MIAMI-DADE COUNTY
DEPARTMENT OF TRANSPORTATION AND PUBLIC WORKS (DTPW)

ADDENDUM NO. 2
June 24, 2022

PROJECT: Improvements to SW 87 Avenue Bridge Over Canal C-100
Project No. 20220010

- A. Volume 3 - Plans. Changes performed are enclosed in revision clouds.
- 1. Delete sheets no. 4, (Typical Section), 5 (Summary of Quantities and Pay Item Notes), 9 (General Notes), 11 (Roadway Plan), 19 (Drainage Structure Sheets), 24 (Drainage Details), 42 and 43 (Canal Cross Sections), 45 (Slope Protection Detail), 59 (Bridge Summary of Quantities), 60 (Plan and Elevation), 62 (Foundation Layout), and 63 (Pile Data Table), and replace with the attached Revised Sheets for Addendum No. 2.
 - 2. Add new sheet from the attached 48in Water Main for Addendum No. 2.
 - 3. Add new sheets from the attached FPL Pole Locations for Addendum No. 2.

CANAL CROSS
SECTIONS

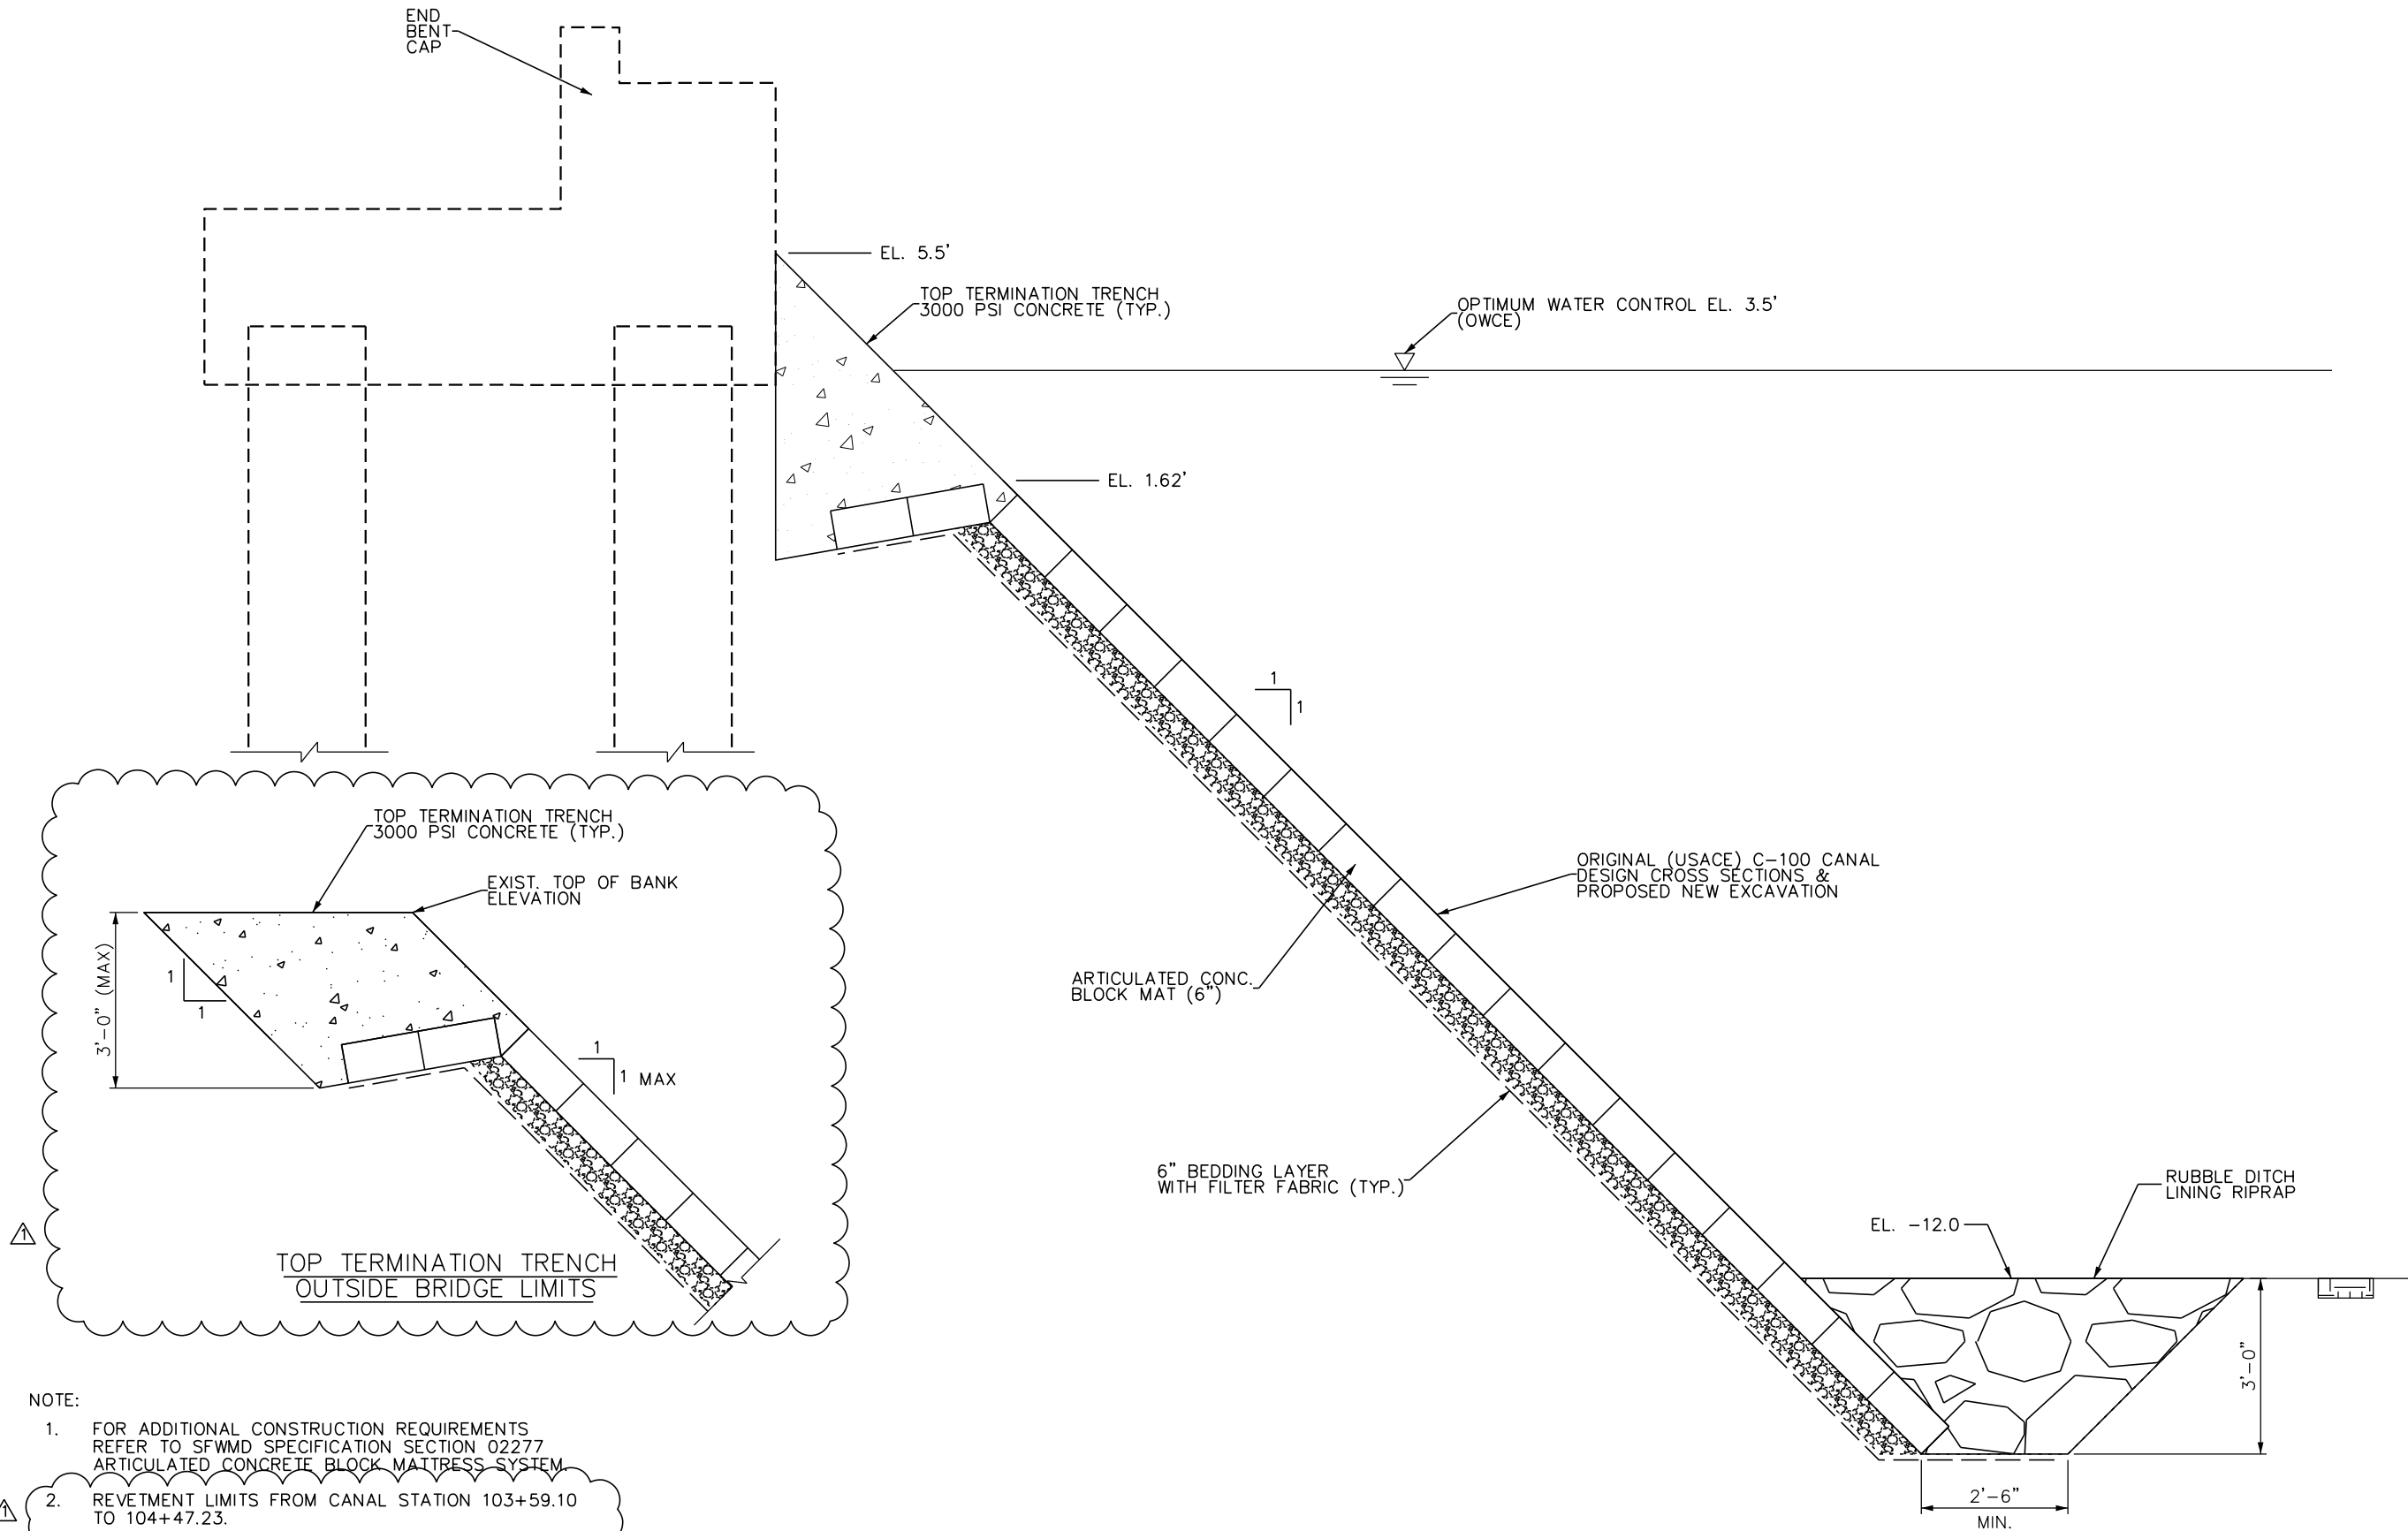
DATE	BY	DESCRIPTION	DATE	BY	DESCRIPTION	DATE	BY	DESCRIPTION
6/23/2022	JC	REVISED QUANTITIES AND REVETMENT LIMITS

PLAN AND ELEVATION

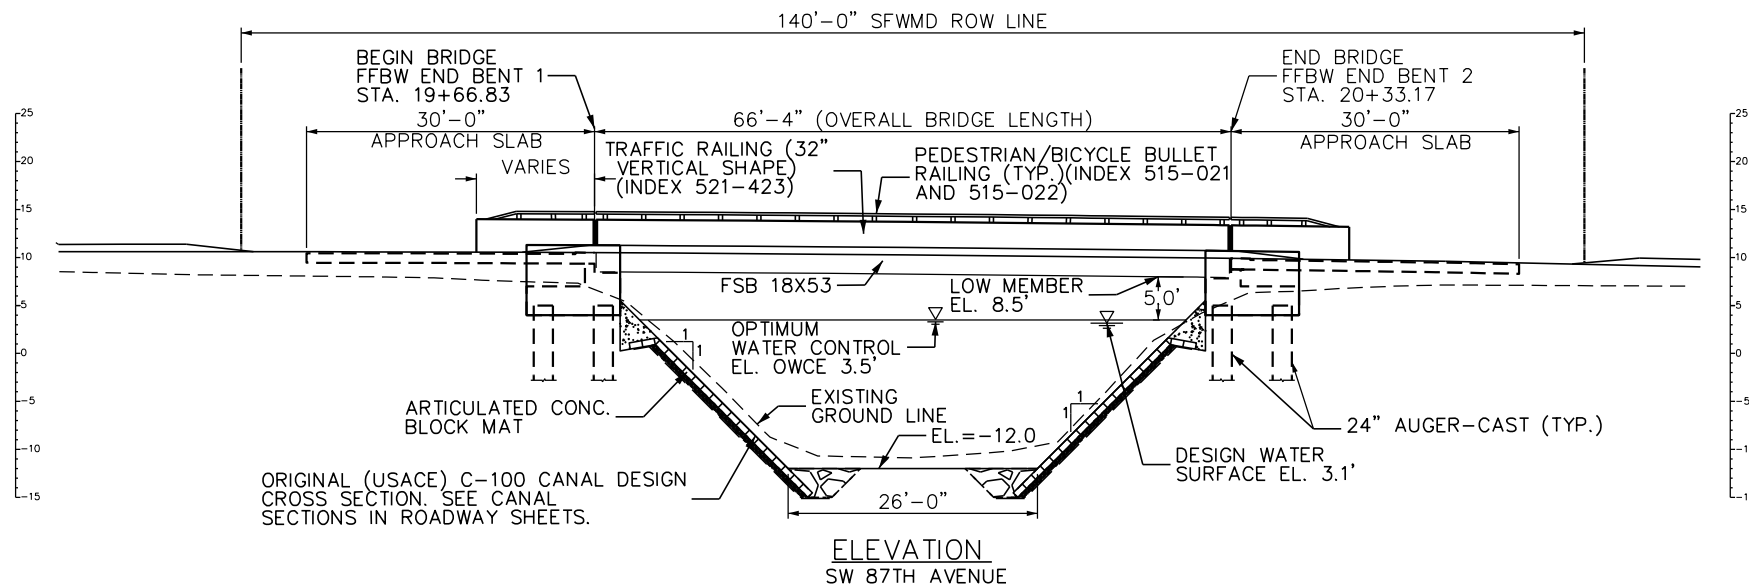
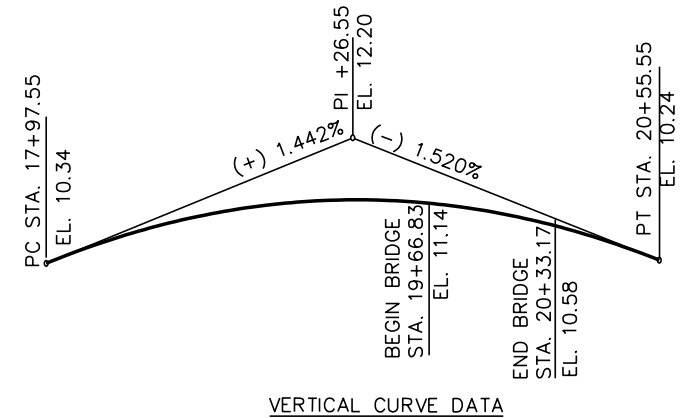
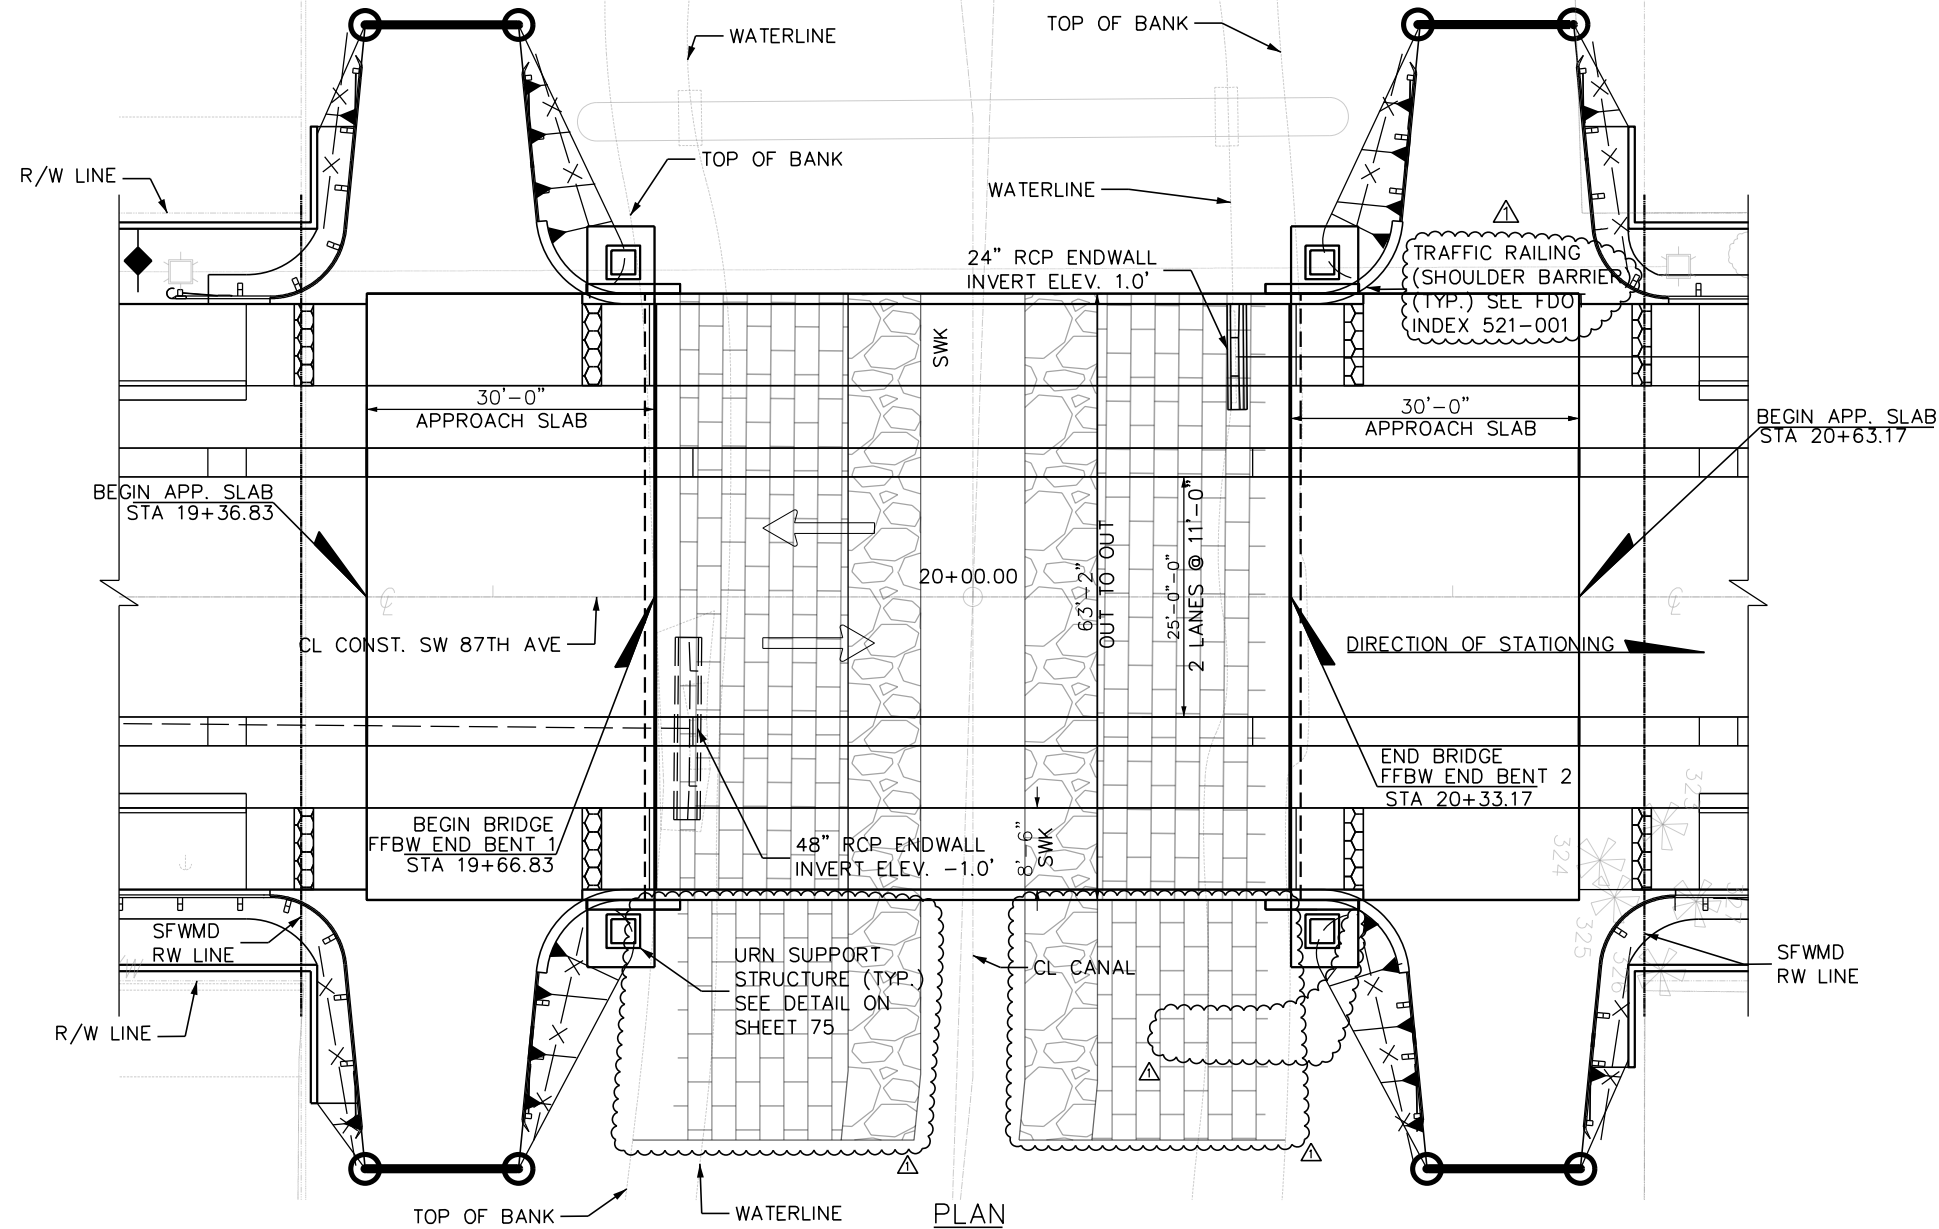
REVISIONS							
DATE	BY	DESCRIPTION	DATE	BY	DESCRIPTION	DATE	BY
6/23/22	JC	REVISED REVETMENT LIMIT & REMOVED LABELS

PLAN

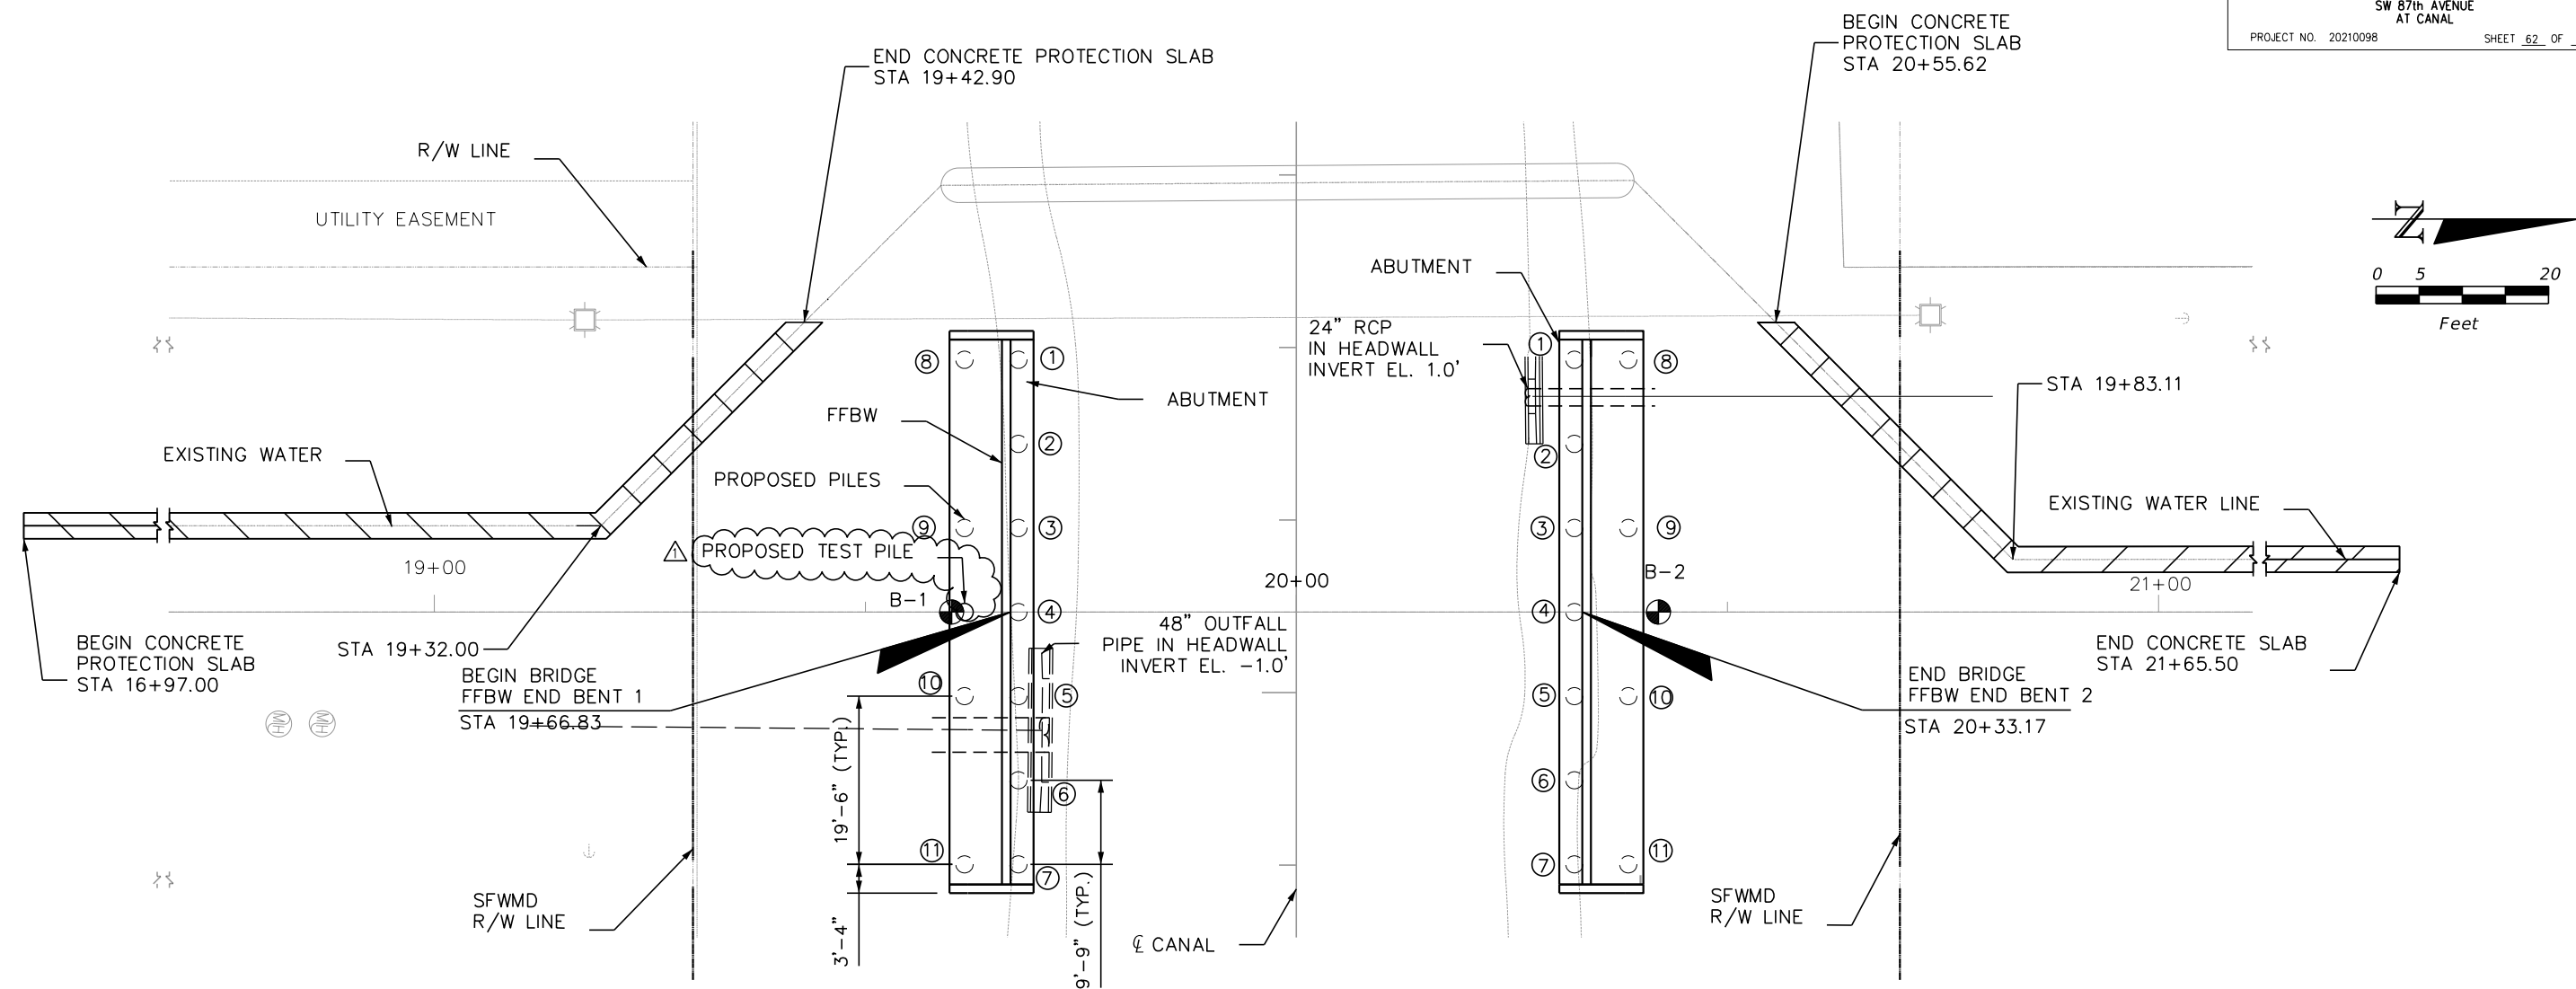
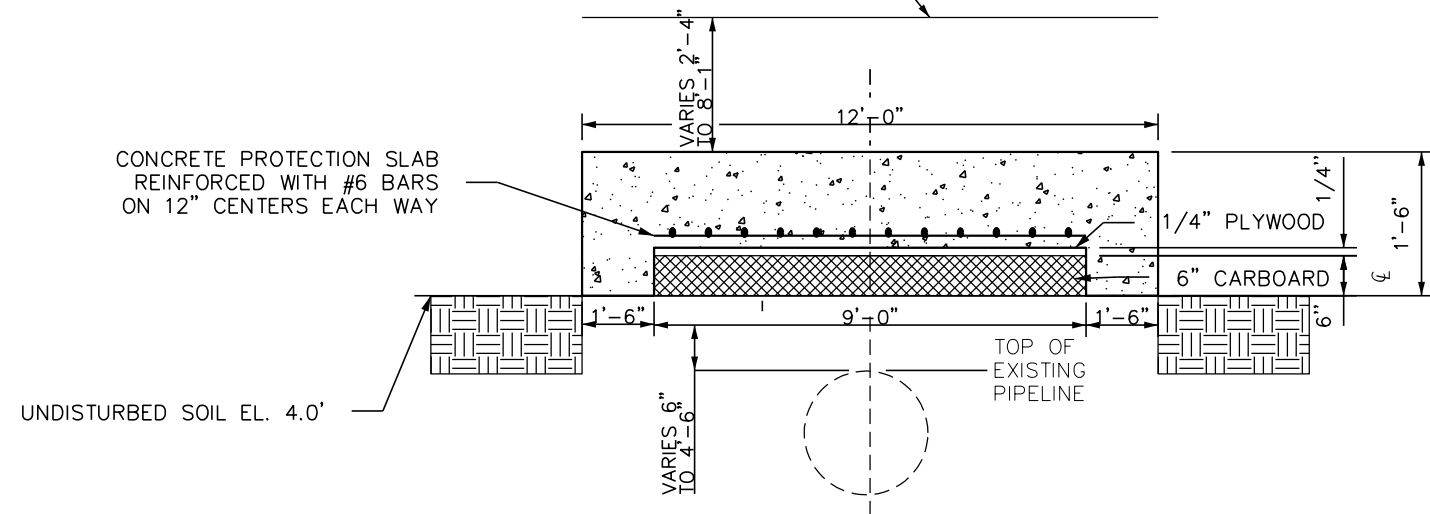
REVISIONS							
DATE	BY	DESCRIPTION	DATE	BY	DESCRIPTION	DATE	BY
6/13/22	JC	ADDED TEST PILE LOCATION AND REVISED LEGEND
